**AIRSPACE CHANGE PROPOSAL
MANCHESTER CONTROL ZONE

CONSULTATION REPORT**

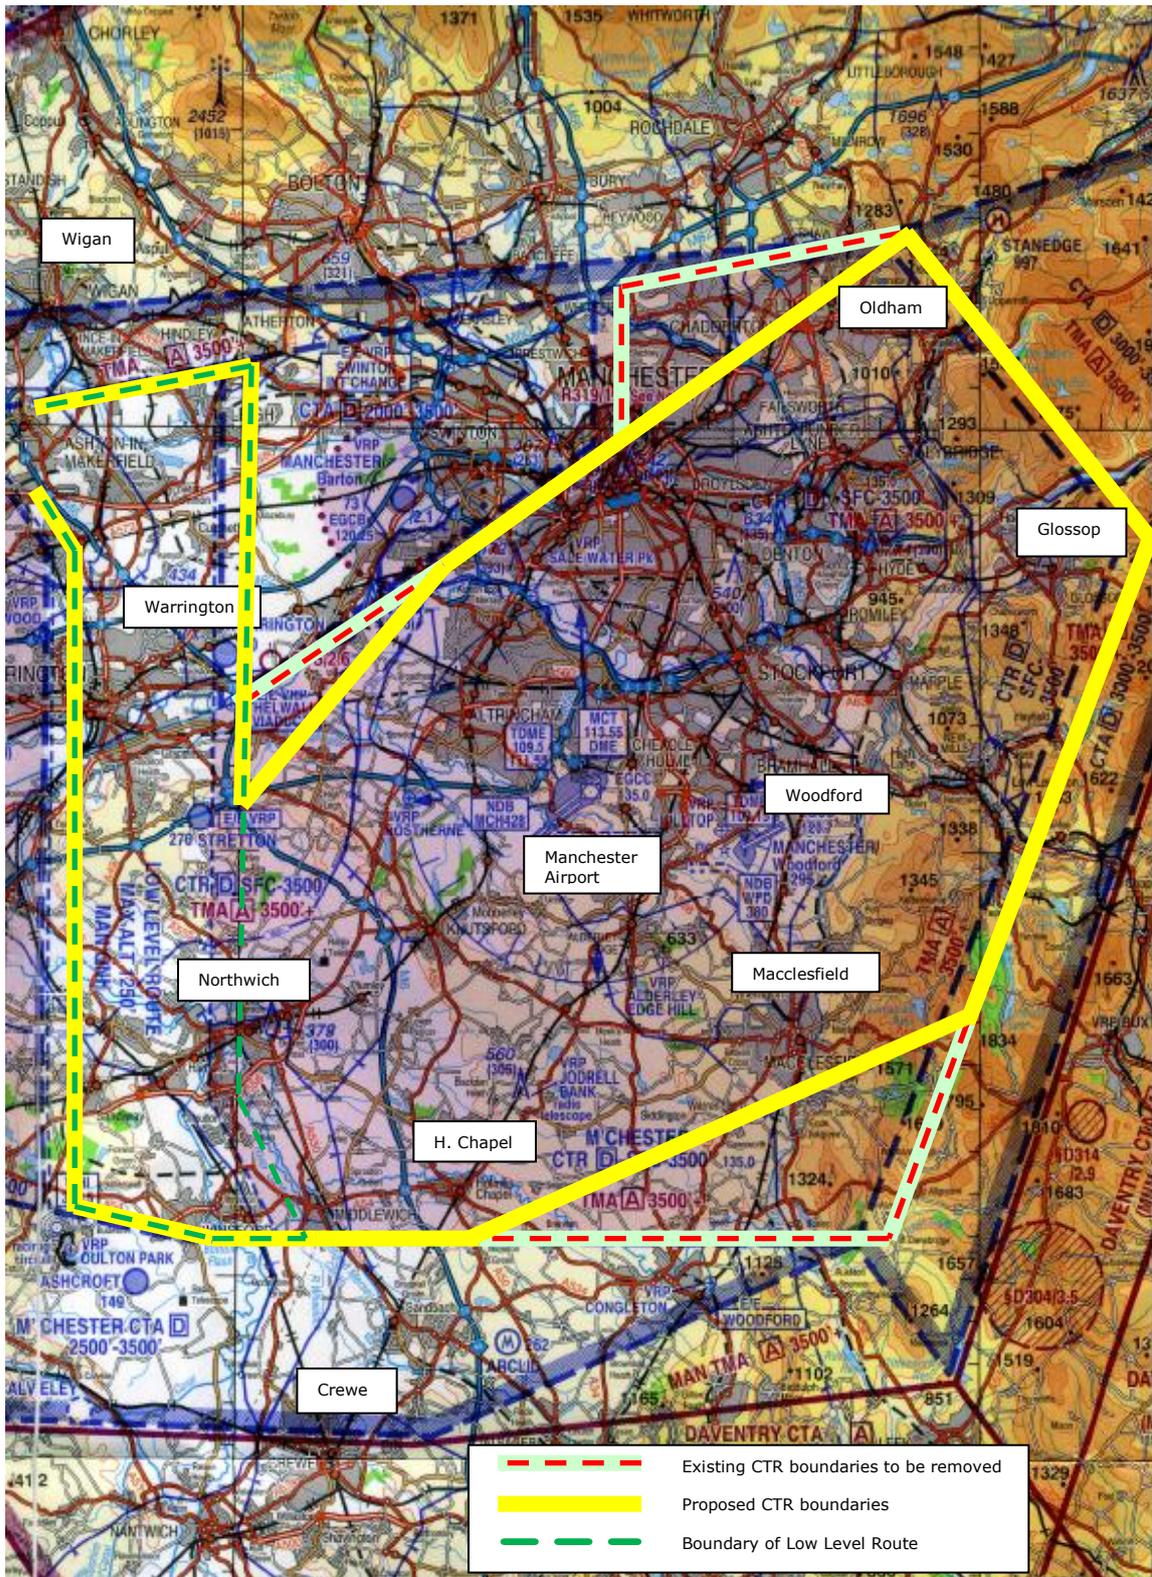
2.7.10 One detailed response could see no reason why the LLR should not be expanded to the south-west and why it should be reserved as part of the Liverpool CTR. This portion of airspace, inside the Liverpool CTR to the south west of the LLR is outside the remit of this airspace change proposal and therefore will not be considered at this time.

**MAP ONE
CTR BOUNDARIES BEFORE AND AFTER PROPOSED CHANGE**

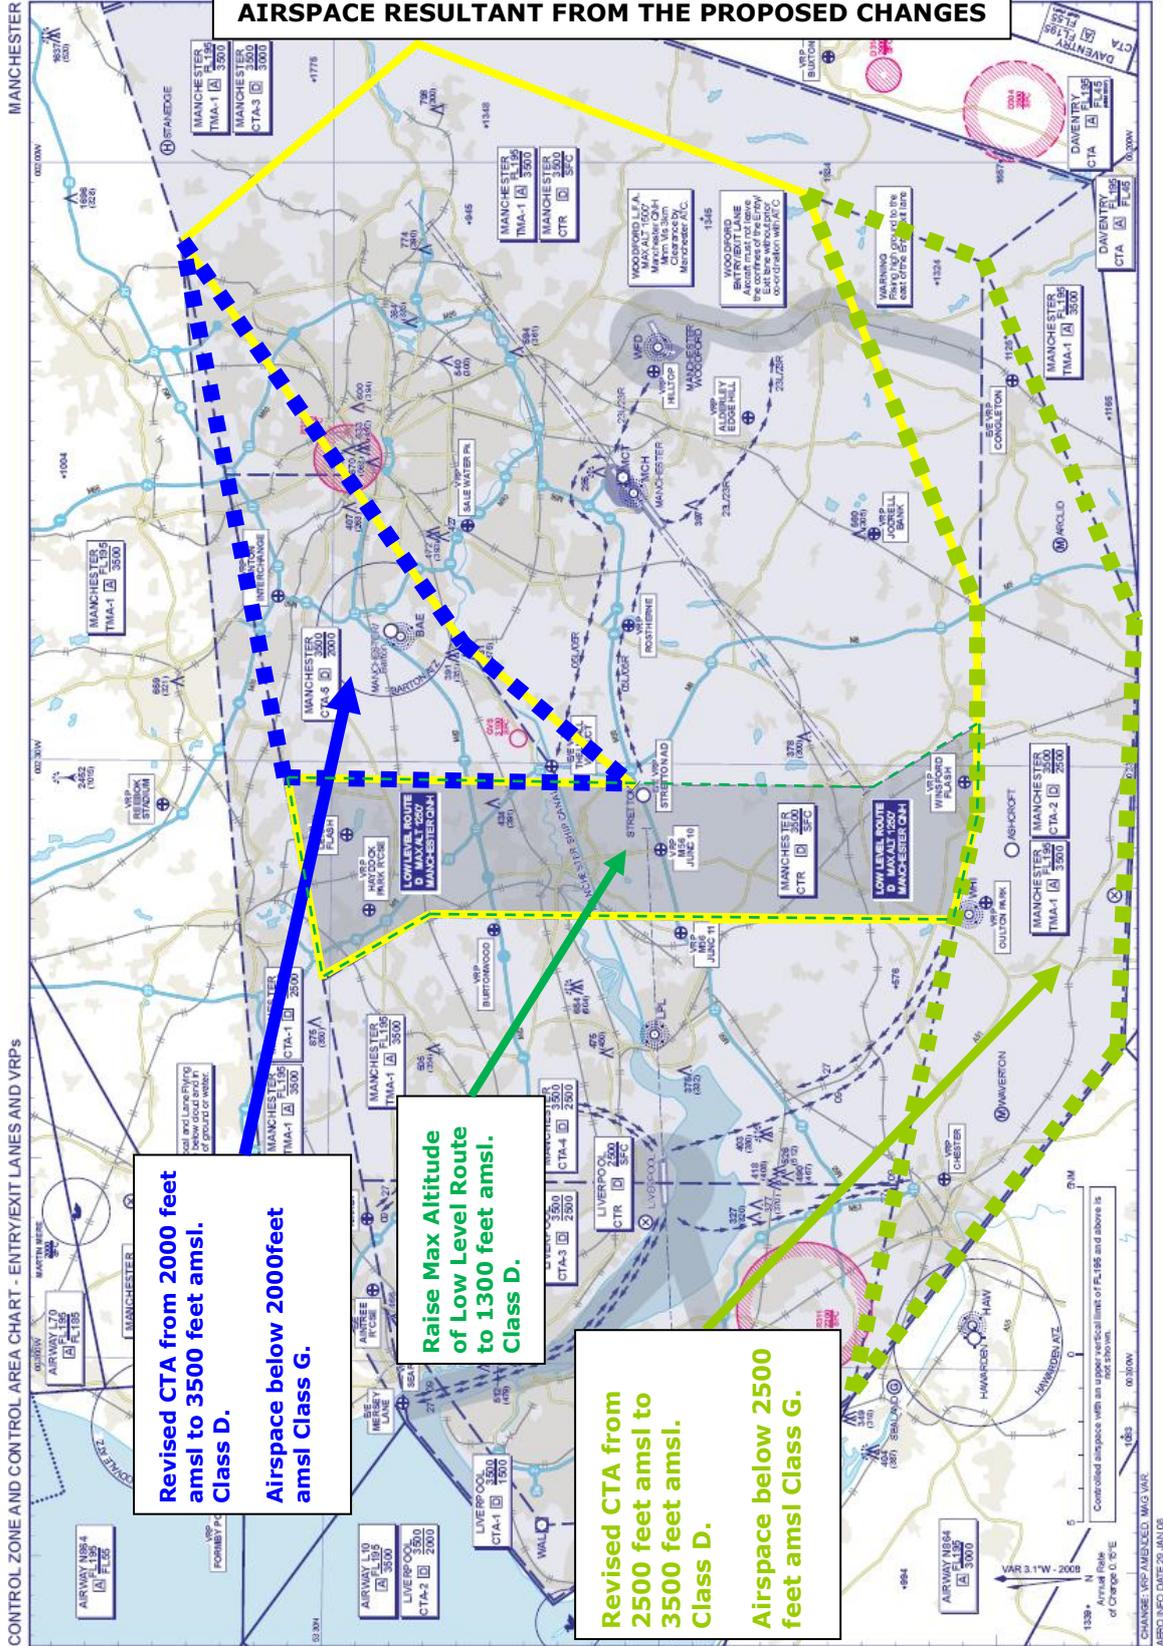
- 2.7.8 **Low Level Route – Lateral Limit.** Extending the lateral limits of the LLR was another of the main issues raised during the Consultation. This issue has been given much consideration, but the only change proposed will be to return a portion of airspace to the east of the LLR (north east of Stretton VRP) to Class G airspace. This increase in Class G airspace has been well received, particularly amongst pilots using Manchester Barton. One response questioned the reason behind the 'kink' in the revised boundary between Stretton VRP and Oldham. This is due to the protection required for the POL & DESIG outbound SID climb profiles, which are based on multi-engine aircraft's engine out performance.

2.7.11 **CTR – Lateral Limit.** Responses welcomed the additional fillet to the north-east of the CTR, which they view as a lateral improvement. Further suggestions though requested that the south east CTR boundary could be taken back on a line towards Glossop. This could bring unknown north east bound traffic (following the edge of higher terrain to the east of the Manchester basin) on a converging track with the 23R final approach. The presence of low cloud (which often occurs around the high ground to the east) could result in traffic taking a more westerly track, flying even closer to the final approach at Manchester. Northbound traffic remaining clear of cloud, tracking to the west of this high ground could encounter further low cloud over the high ground in their twelve o'clock, north of Glossop. This could lead to a scenario where the traffic alters course onto a southerly track, again close to the extended final approach track.

3.1.1 Careful consideration has been given to the suggestions of reclassifying more of the Manchester CTR to Class G, however the rationale (as documented in paragraph 2.7 of this report) for not accepting the suggestions is considered to be sound. There are therefore no modifications to the original Proposal in relation to reclassifying more of the Manchester CTR to Class G.
